VILLAGE OF HOMEWOOD

MEMORANDUM

Topic: Case 24-12: Washington Park Commercial Subdivision – Preliminary Plan and Final Plat

Figure 1. Proposed Resubdivision (outline in yellow). The new lot will be located at the northeast corner of the existing subdivision (outlined in red) near the intersection of Maple Avenue and Halsted Street.

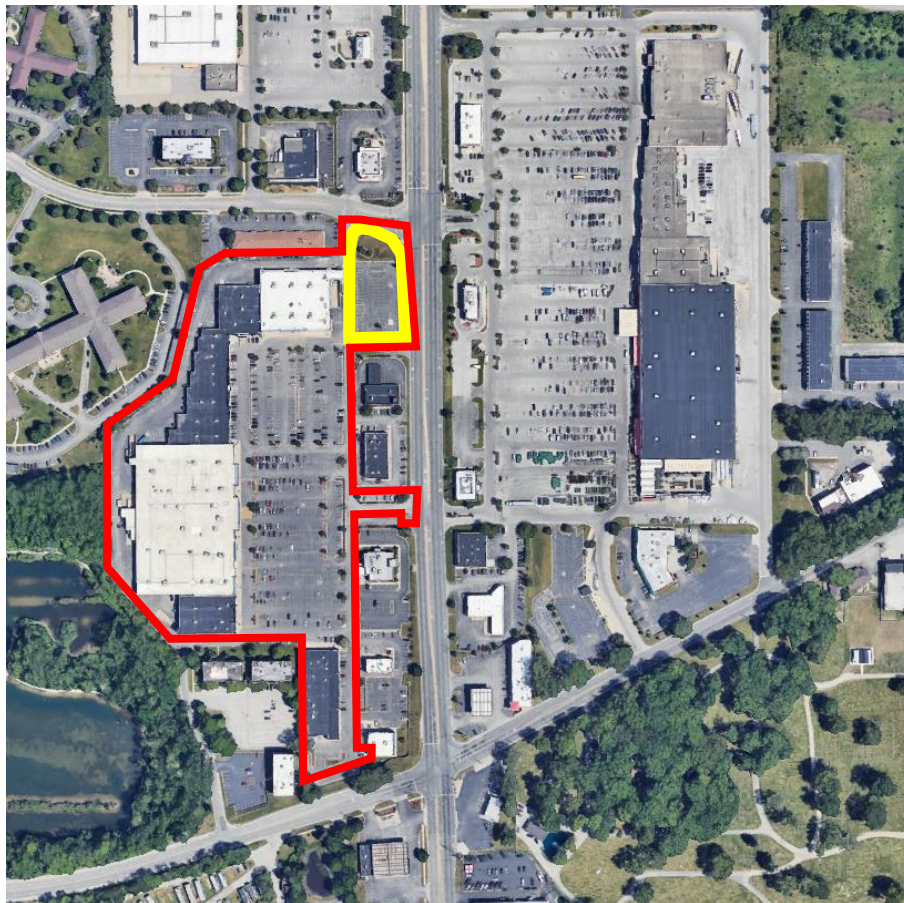
In addition, the application has proposed that an area of 4,593 square feet (0.1 acres), along Halsted Street and Maple Avenue be dedicated to the Village of Homewood for public improvements. The Village has not agreed to any land being dedicated to us. **Staff recommends that the final plat of subdivision be revised to eliminate the dedication to the Village of Homewood.**

1. Revise the final plat to remove all areas dedicated to the Village of Homewood;
2. Release Sign Easement for the existing monument sign (Document 9598945);

Figure 2. Easement Details from the proposed final plat drawing prepared by the applicant. All easements affecting the development of the proposed outlot, including utility easements, sign easements, and access easements, are included in this drawing.

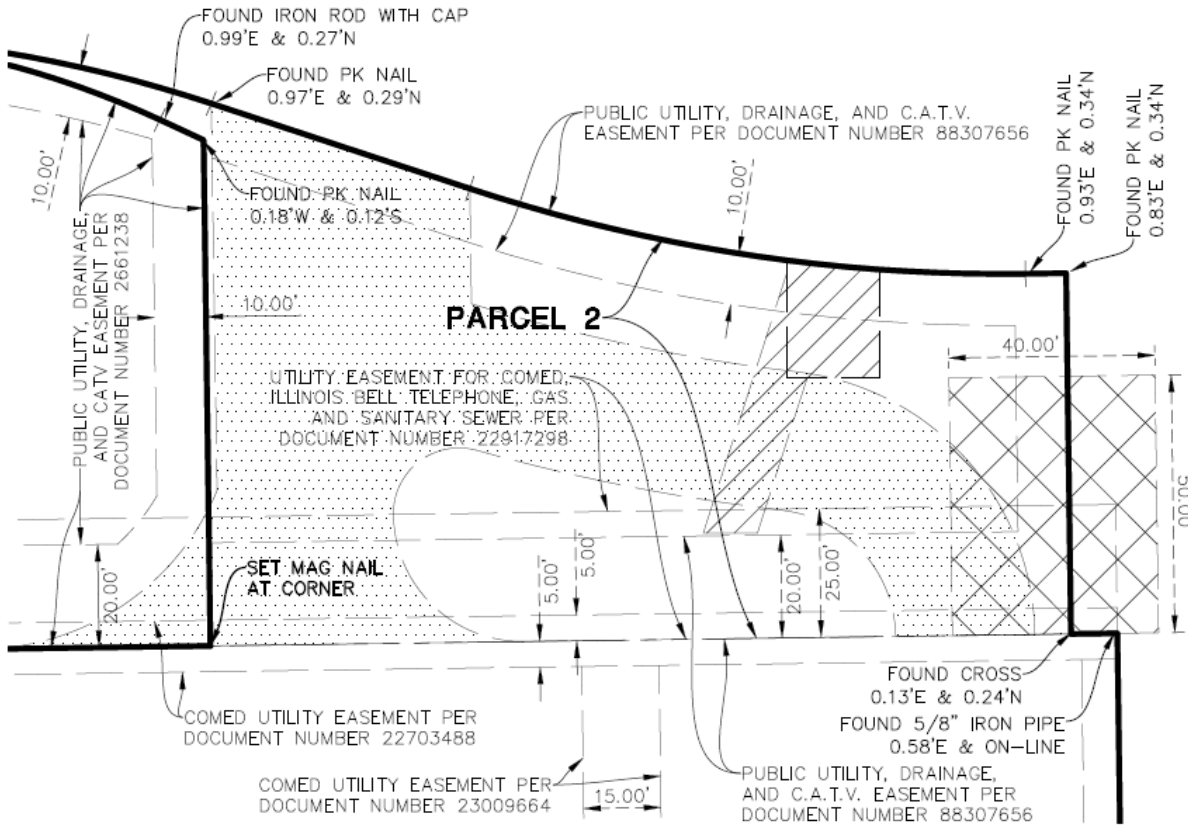
- **Monument Easement:** The applicant has provided an easement for the existing historical monument in recognition of the Washington Park Raceway. This easement overlaps with the proposed outlot. The sign easement area is approximately 22' x 20', or 440 square feet, in area. The Village plans to move this monument and will no longer need the easement. ***Staff recommends a condition that the easement be removed as a condition of final plat approval.***

- **Vehicle Ingress and Egress Easement:** An existing ingress/egress easement exists along Halsted Street at the northeastern corner of the proposed outlot. This 50' x 40' (2,000 square feet) easement was originally intended to provide space for an additional driveway into the Washington Park Plaza shopping center. This easement will not be utilized for an additional driveway, as a driveway placed at this location would not meet the spacing requirements required by the Village of Homewood.

The easements are detailed in **Figure 2**. While there are a large number of easements proposed on the site, the easements are generally concentrated on the northern portion of the proposed outlot ("Lot 2"), and the site may be designed in a manner that maintains the usefulness for a variety of commercial uses without interference with the existing easements.

Figure 3. Conceptual site plan drawing submitted by the applicant, showing a potential scenario for a quick-service restaurant (QSR).

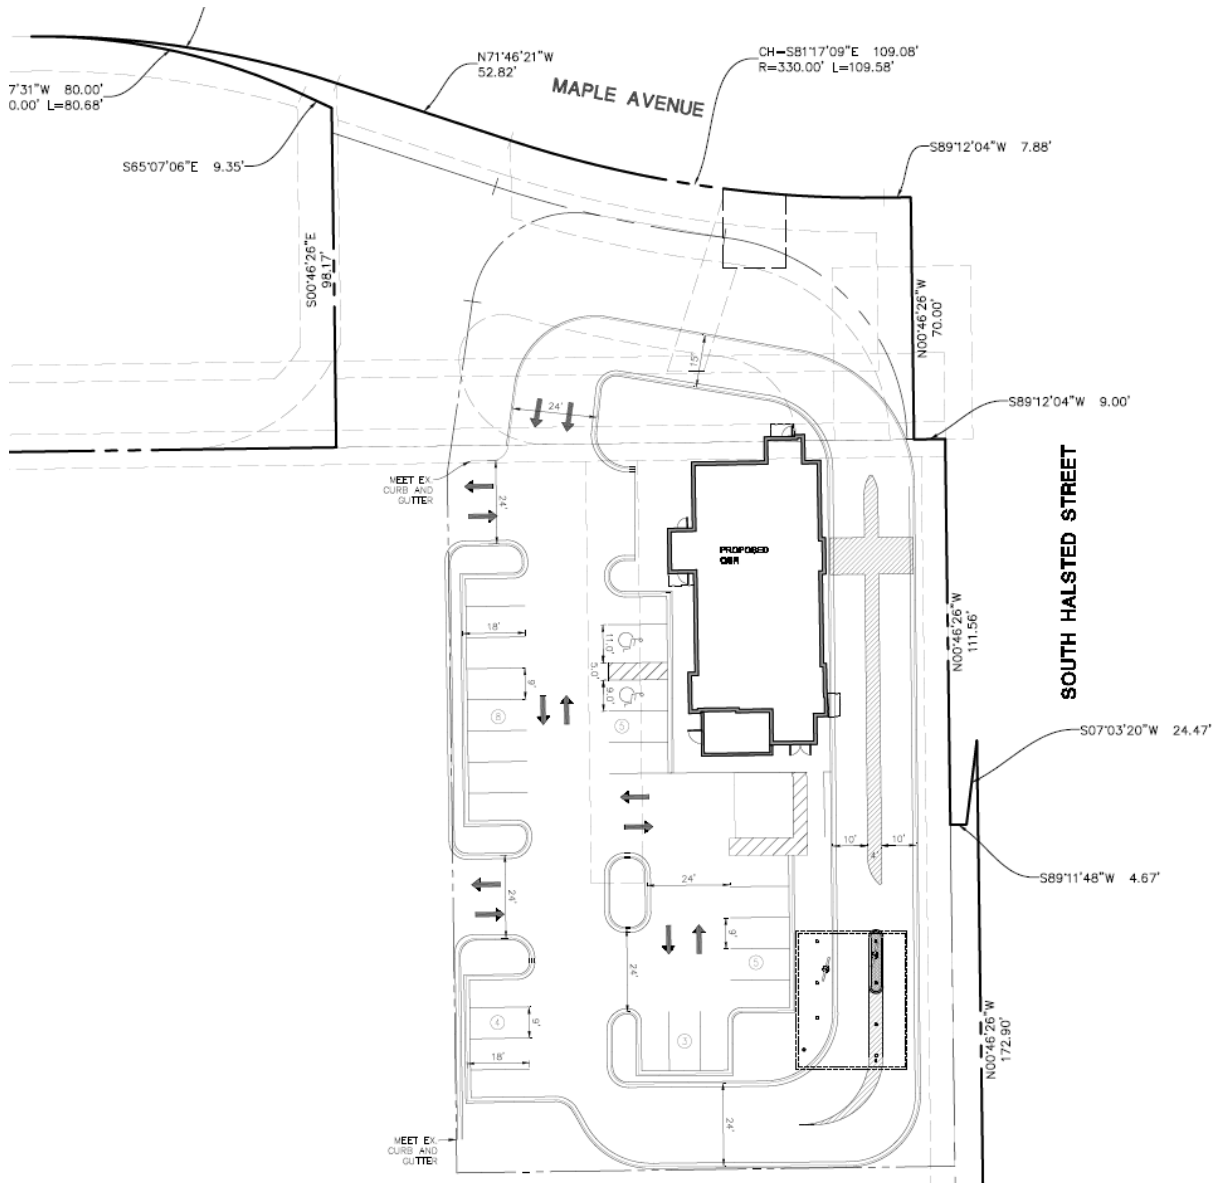
Figure 3 overlays the proposed site plan with existing easements, demonstrating the lack of conflicts between the easements and the development being considered for the property.
